SUBJECT: Draft Notice of Proposed Rulemaking to Amend the Safety Standard for
Automatic Residential Garage Door Operators

Safety Standard for Automatic Residential Garage Door Operators

ACTION: Notice of proposed rulemaking.

Figure 2

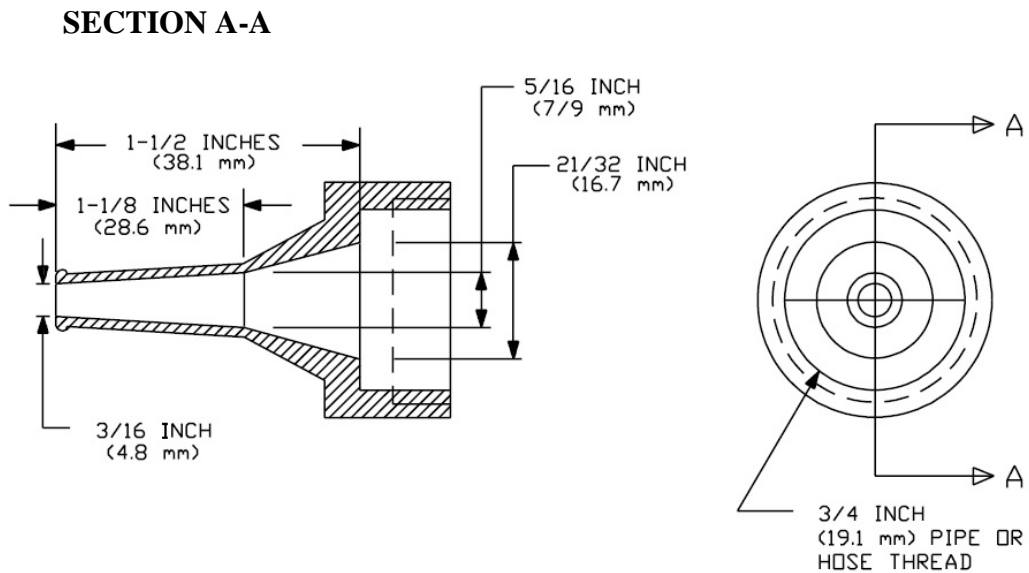
(2) External entrapment protection devices are to be indirectly sprayed using a hose having the free end fitted with a nozzle as illustrated in figure 2 and connected to a water supply capable of maintaining a flow rate of 5 gallons (19 liters) per minute as measured at the outlet orifice of the nozzle. The water from the hose is to be played, from all sides and at any angle against the floor under the device in such a manner most likely to cause water to splash the enclosure of electric components. However, the nozzle is not to be brought closer than 10 feet (3.05 m) horizontally to the device. The water is to be sprayed for 1 minute.

Figure 3

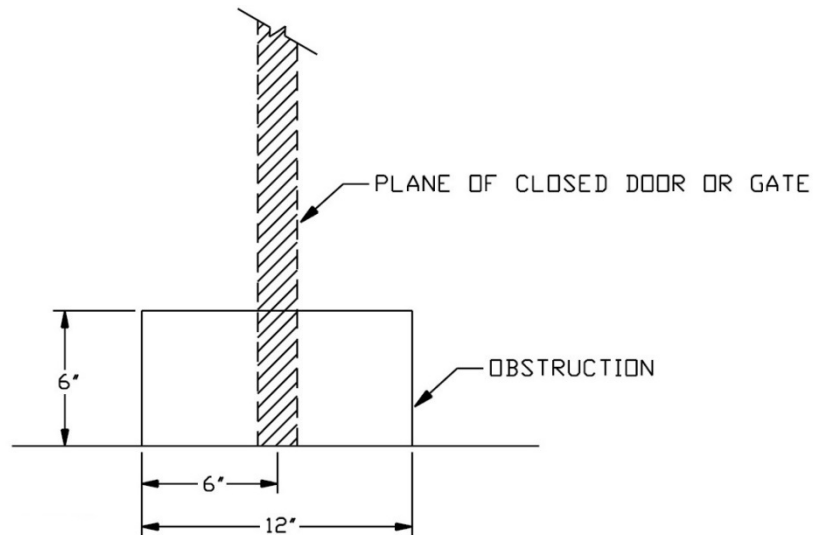
(c) The obstruction noted in paragraphs (a) and (b) of this section shall consist of a white vertical surface 6 inches (152 mm) high by 12 inches (305 mm) long. The obstruction is to be centered in the opening perpendicular to the plane of the door when in the closed position. See figure 3.

Figure 4

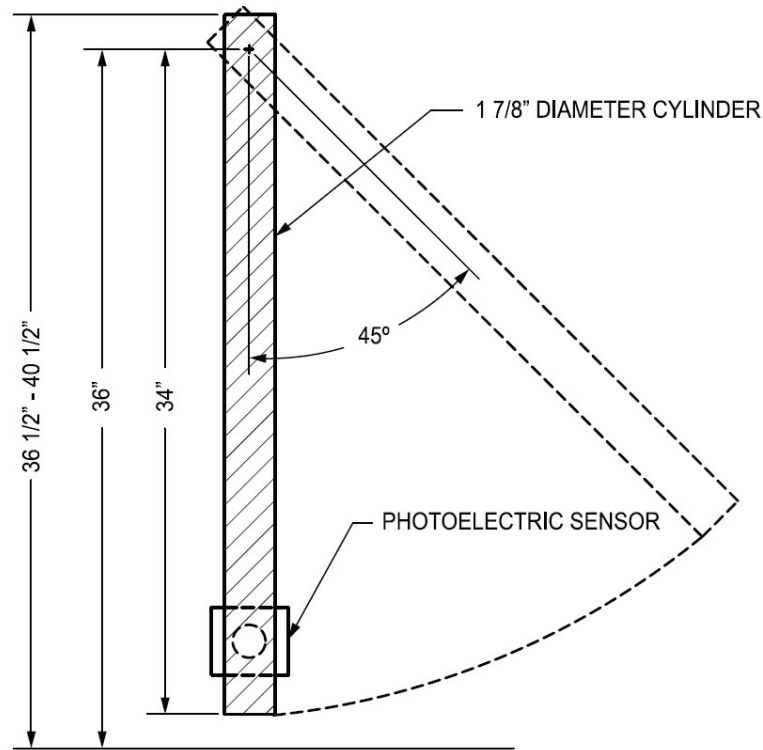
(2) The moving object is to consist of a $1\frac{7}{8}$ inch (47.6 mm) diameter cylindrical rod, $34\frac{1}{2}$ inches (876 mm) long, with the axis point being 34 inches (864 mm) from the end. The axis point is to be fixed at a point centered directly above the beam of the photoelectric sensor 36 inches (914 mm) above the floor. The photoelectric sensor is to be mounted at the highest position as recommended by the manufacturer. The rod is to be swung as a pendulum through the photoelectric sensor's beam from a position 45 degrees from the plane of the door when in the closed position. See figure 4.

(4) When the test fixture of figure 4, prior to conduct of the test, interferes with the photoelectric sensor detection zone, the tests per paragraphs (d)(1) through (4) of this section may be conducted instead per paragraph (f)(4) of this section.

Figure 5

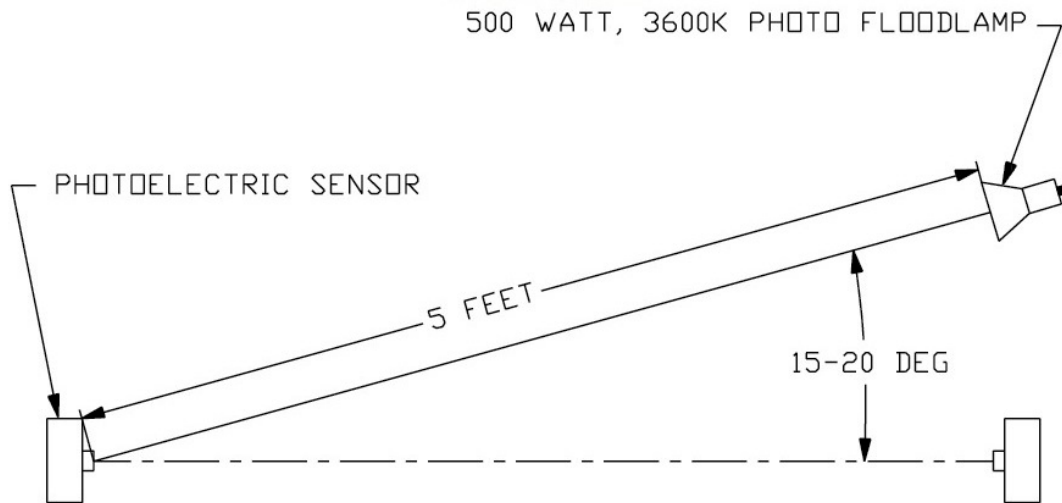
(2) To determine compliance with paragraph (e)(1) of this section, a 500 watt incandescent or equivalent minimum rated, 3600K or lower color rated flood lamp is to be energized from a 120-volt, 60-hertz source. The lamp is to be positioned 5 feet from the front of the receiver and aimed directly at the sensor at an angle of 15 to 20 degrees from the axis of the beam. See figure 5.

UL added requirements for alternate sources of light for the photoelectric sensor ambient light test (§ 1211.11(e)(2)). The current test method specifies a specific DXC-RFL-2 flood lamp, which is becoming difficult to obtain in the marketplace. Instead the requirement will specify the minimum required wattage (500W) and maximum color temperature (3600K) of the bulb to allow for available light sources without affecting the test results.

Figure 6

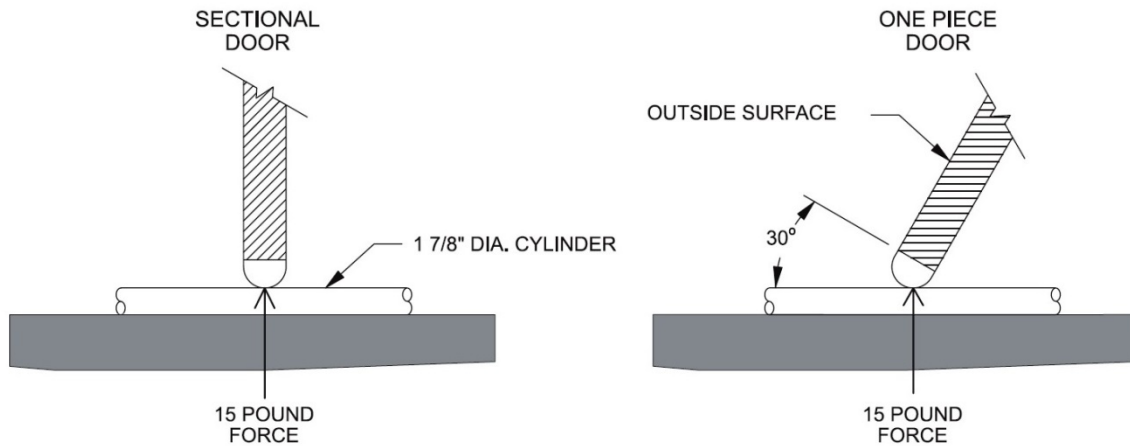
(a) *Normal operation test.* (1) When installed on a representative residential door edge, an edge sensor shall actuate upon the application of a 15 pounds (66.7 N) or less force in the direction of the application. For an edge sensor intended to be used on a sectional door, the force is to be applied by the longitudinal edge of a 1⁷/₈ inch (47.6 mm) diameter cylinder placed across the switch so that the axis is perpendicular to the plane of the door. For an edge sensor intended to be used on a one piece door, the force is to be applied so that the axis is at an angle 30 degrees from the direction perpendicular to the plane of the door. See figure 6.

Figure 7

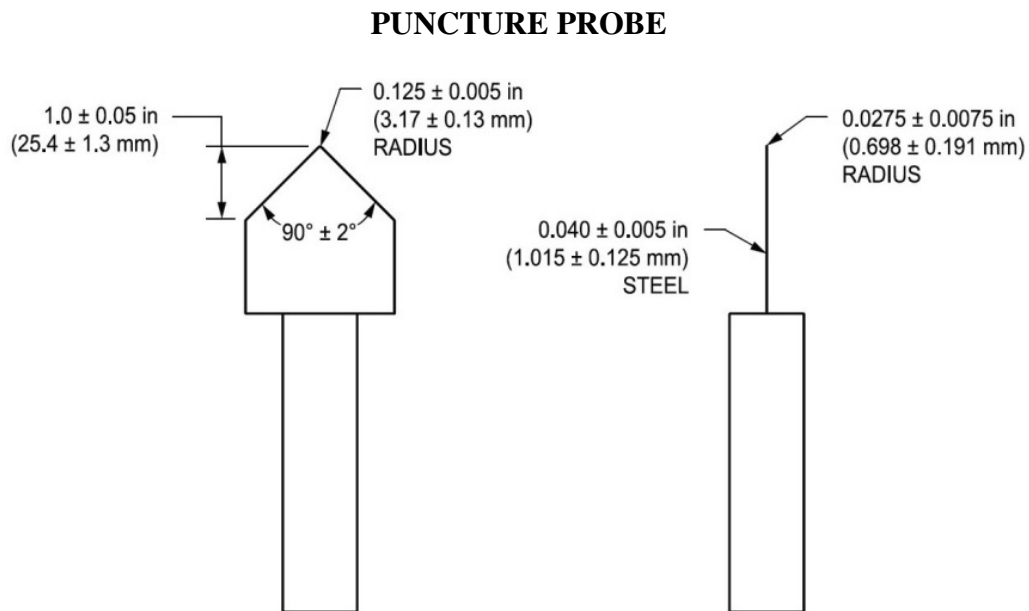
- c. Revising paragraph (d); and
- d. Revising Figure 7.

(2) For a vertically moving door, a sample of the edge sensor is to be installed in the intended manner on a representative door edge. The probe described in figure 7 is to be applied with a 20 pound-force (89N) to any point on the sensor that is 3 inches (76 mm) or less above the floor is to be applied in the direction specified in the Edge Sensor Normal Operation Test, figure 6. The test is to be repeated on three locations on each surface of the sensor being tested.

(3) For horizontally sliding doors, sample of the edge sensor is to be installed in the intended manner on a representative door edge. The probe described in figure 7 is to be applied with a 20 lbf (89 N) to any point on the sensor when the door is within 3 in (76 mm) of its fully open position and within 3 in (76 mm) of any stationary wall. For each type of door, the force is to be applied in the direction specified in the Edge Sensor Normal Operation Test, figure 6. The test is to be repeated on three locations on each surface of the sensor being tested.
